Scott Groundwater Sustainability Plan Comments QVIC

A) COMMENT OVERVIEW

B) SUGGESTIONS FOR IMPROVING THE SCOTT VALLEY INTEGRATED HYDROLOGIC MODEL

C) COMMENTS ON SPECIFIC GSP SECTIONS USING THE COMMENT FORM PROVIDED

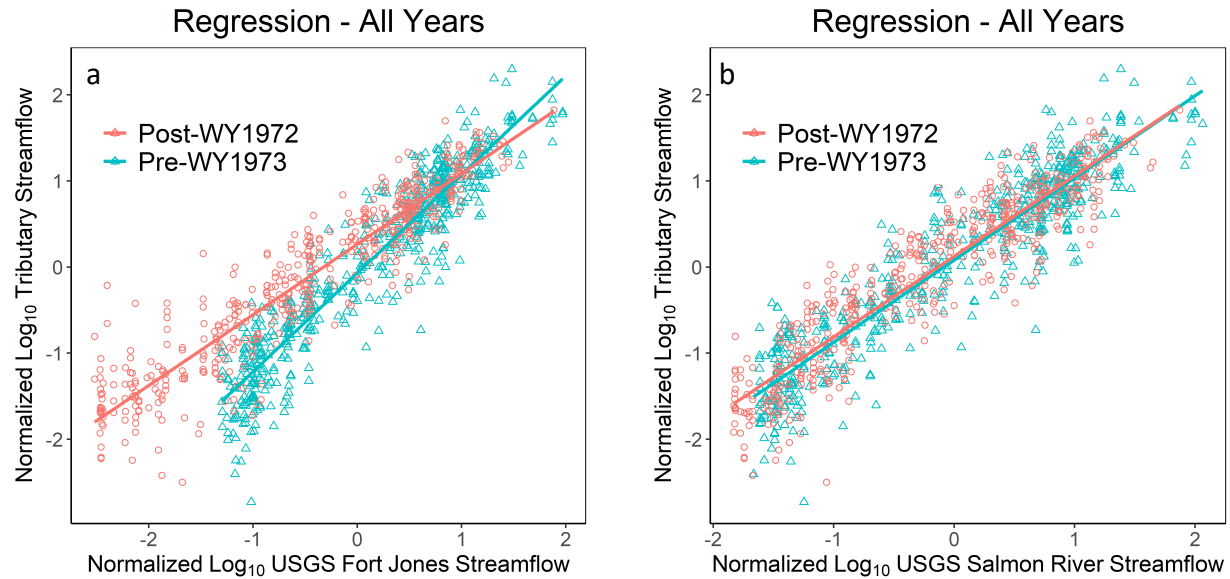
Scott River summer flows appear to have decreased significantly since the 1977 drought, so the data were split and separate regressions were developed for the WY 1957–1972 and WY 1973–2016 study periods (Figure 1a). For those tributaries that do not have any measured data during the WY 1973–2016 period, the WY 1957–1972 regression is used. Given that there is extremely strong evidence that the relationship between tributary flows and Scott River flows changed between the WY 1957–1972 and WY 1973–2016 periods (i.e., Figure 1a), it does not make sense to apply the WY 1957–1972 regressions without adjusting for that difference. Rather than doing two separate regression models (i.e., one for each period), it would make more sense to just have a single regression model covering all years, but include “Period” as a categorical variable (to account for the difference in intercept between the periods), and an interaction of “Period” and Fort Jones (to account for the difference in slope between the periods). In contrast, the current approach does not take maximum use of the available data, ignoring factors that are known to be important (i.e., the difference between the periods).

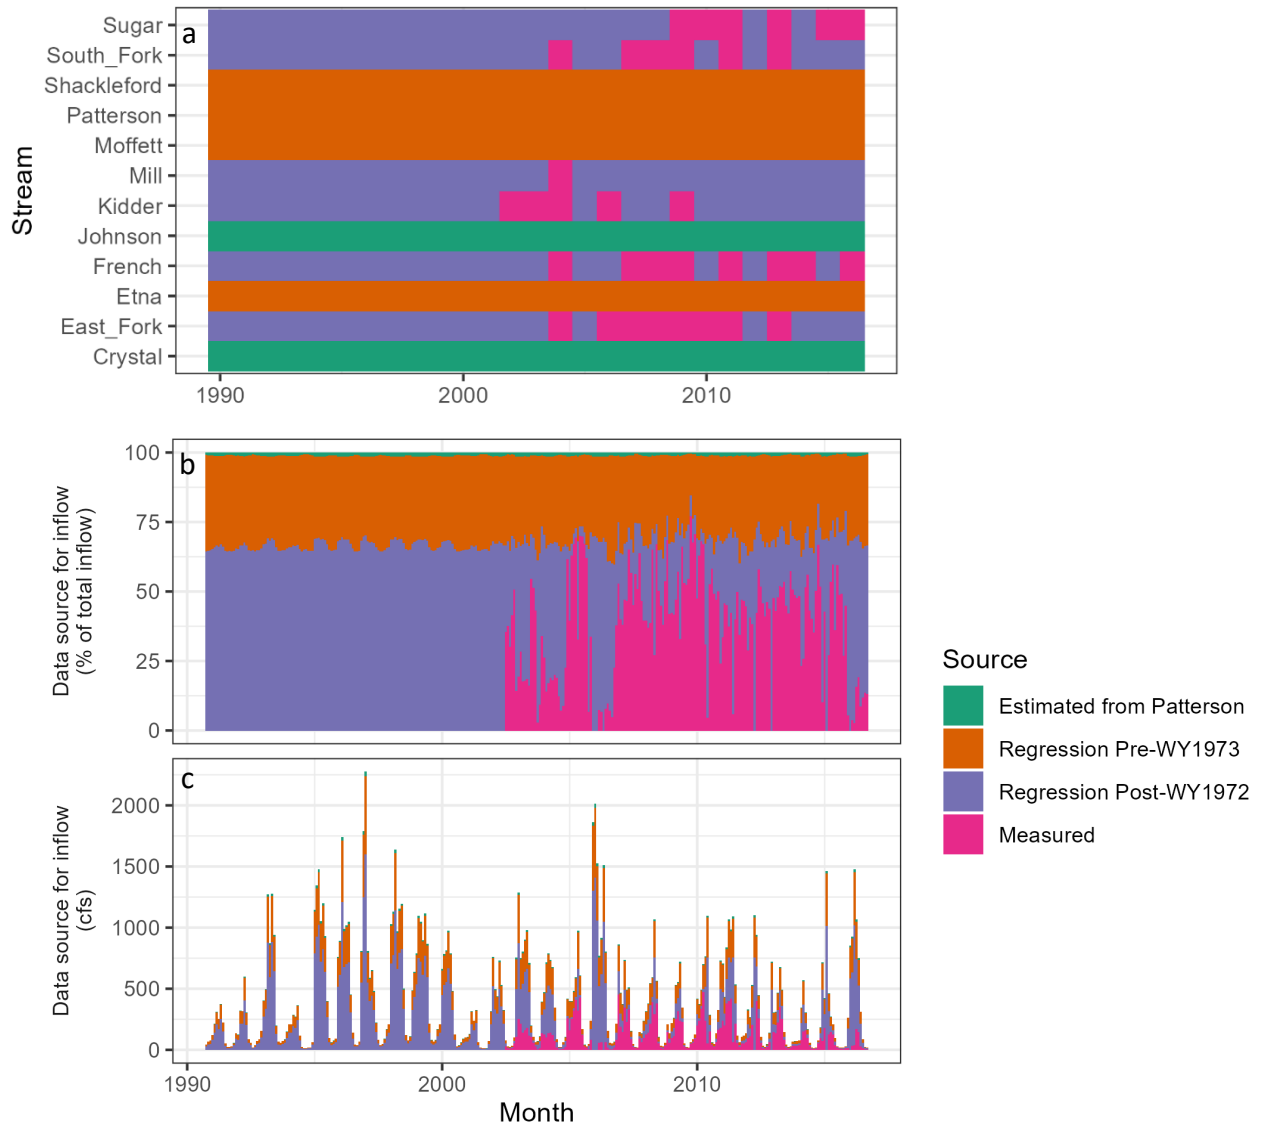
The first thing to recognize about the gap-filling is that gaps are substantial (Figure 2a), so the methods for filling them matters. For the current SGMA GSP, the SVIHM was run for WY1991–2018. Prior to WY 2002, all (100%) of tributaries were estimated using regression against the USGS gage. Since WY 2002, additional gages have been installed but most were operated in only a subset of recent years and now only Sugar Creek and French Creek are still operational (Figure 2). The version of SVIHM used for SGMA did not use any tributary data for 2017–2018. The percent of total estimated inflows in a month that are based on measurements (i.e., gages) only sporadically exceeds 50% (Figure 2b, 2c). The USGS 11519500 gage that is the source for all the regression-based estimates is located at the outlet of Scott Valley. It is problematic to use a gage that is the surface water output of a groundwater basin to estimate the surface water inputs to the same basin, because that groundwater basin exerts profound natural and human influences on hydrology, including water diversions, groundwater pumping, evapotranspiration, groundwater recharge, and leakage of groundwater to streams. In reality, these influences vary not only seasonally (e.g., spring vs. fall) but also inter-annually (i.e., wet years vs. dry years), but using linear regression assumes a constant relationship between the input and output. For example, long-term management changes can affect the relationship between inflows and outflows (i.e., see Figure 1a showing effects of increased groundwater extraction). This gage is also used for calibration and verification of the SVIHM. Given that inflows are an important driver of groundwater dynamics, using the outflow to estimate inflows may artificially inflate the apparent accuracy of the SVIHM (because estimated inflows are automatically scaled based on measured outflows).

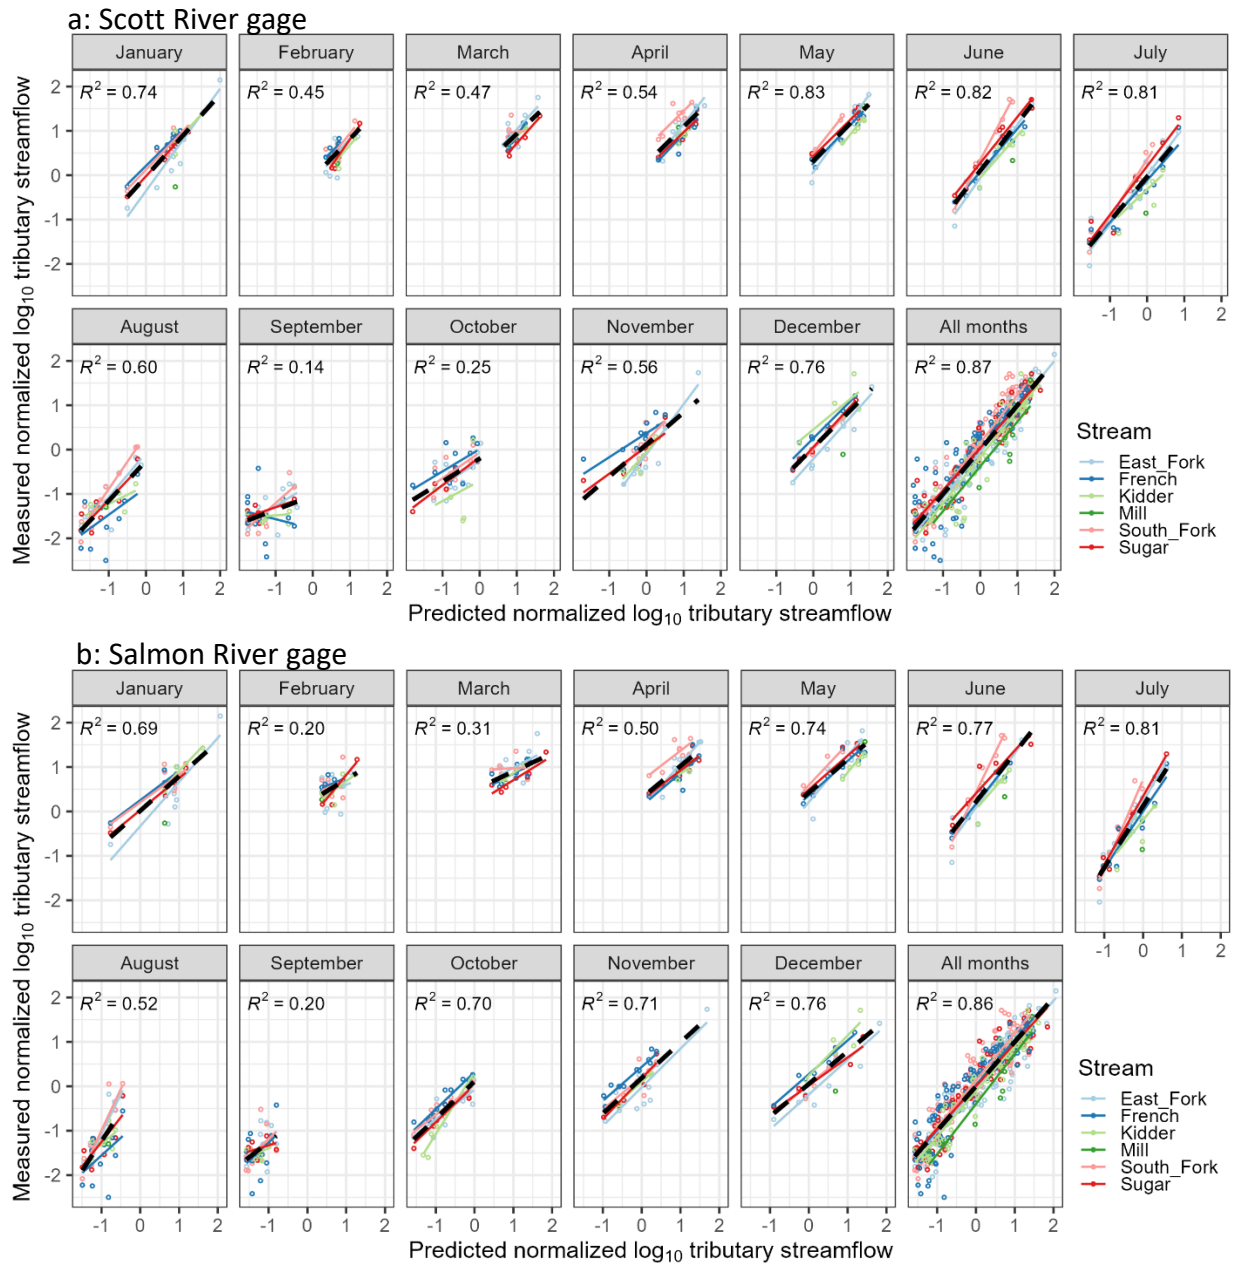
In contrast to the major differences in the relationships between tributaries flows and Scott River flows for the WY 1957–1972 and WY 1973–2016 periods (Figure 1a), there appears to be no difference between the periods when the Salmon River gage is used instead (Figure 1b). The lack of difference between these periods in the Salmon River models suggests that for tributaries that have no post-1972 flow data (i.e., Shackelford, Patterson, and Etna creeks)(Figure 2a), it is likely better to use the Salmon River model for gap-filling additional months (i.e., maybe June–December for these tributaries, instead of the September–November we are recommending for the other tributaries?). The recommendation for June–December is based on the observation that the between-period divergence occurs at normalized \log_{10} Scott River flows less than zero (Figure 1a) and in the WY 1973–2016 period such flows tend to occur more frequently in June–December than other months (Figure 4a).

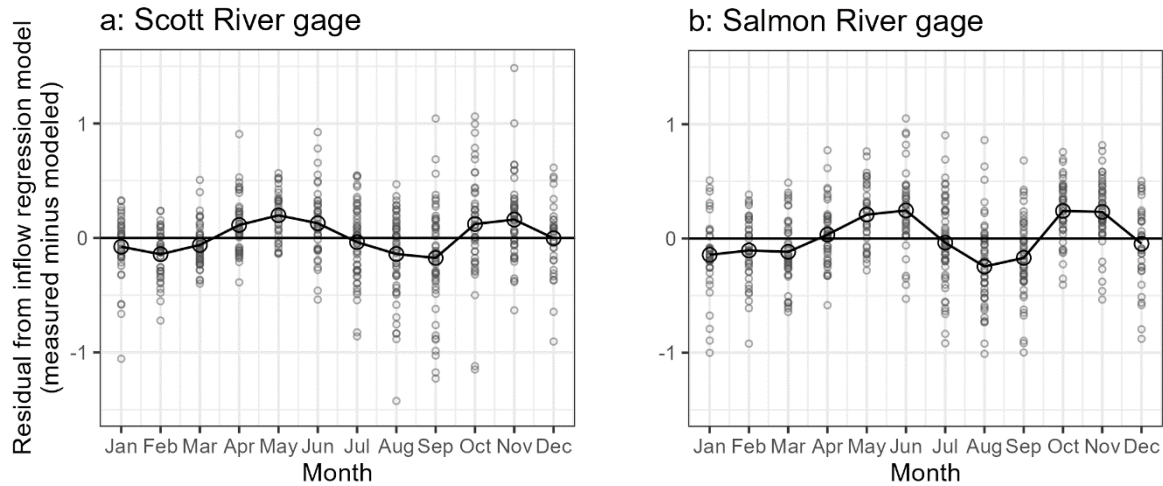
One additional suggestion for potential additional refinements to the methods for filling data gaps that we do not currently have time to test, but want to mention here so it could potentially be followed up on later, is to use hierarchical models and account for watershed area. The SVIHM's normalization (a.k.a. "standardizing", our preferred term) of the flow data (subtracting the mean and dividing by standard deviation, with the mean and standard deviation calculated individually for each site based on that site's period of record) is intended to allow all tributaries to be included together in the same regression model. However, we have some concerns that for sites with short records (e.g., 11 months at Mill Creek, 6 months at Etna and Patterson creeks), there are far too few data points for the mean and standard deviation to be representative of long-term patterns, which could lead to artifacts in the regression outputs. A possibly more robust alternative would be to instead convert the flow data to specific discharge (i.e., flow per watershed area in units of cfs/mi² or its metric areal equivalent mm/d), then standardizing by subtracting the mean and dividing by standard deviation (with the mean and standard deviation calculated from the entire pool of specific discharges from all sites, rather than calculating the mean and standard deviation only from each site's period of record). From these standardized specific discharges, a single hierarchical model (a.k.a. mixed effects model) could be constructed with appropriate random effects to explicitly account for inter-site differences. R packages available for implementing such models include 'mgcv', 'lme4', and 'nlme'. A hierarchical model could help account for inter-site differences. For example, not surprisingly given its the relatively low elevation watershed, Moffett Creek appears to have a greater percent of its annual flow occur during January–March than other tributaries and then a lesser percent of its annual flow occurs during May–June snowmelt runoff (not shown here). There are clear, albeit relatively small, seasonal patterns in the residuals (calculated as measured minus modeled) in both the Scott River and Salmon River regression models, with both models under-predicting tributary flows in May–June and October–November underpredicting tributary flows in January–March and August–September (Figure 5). A hierarchical model would likely help remove the seasonal patterns in model residuals.
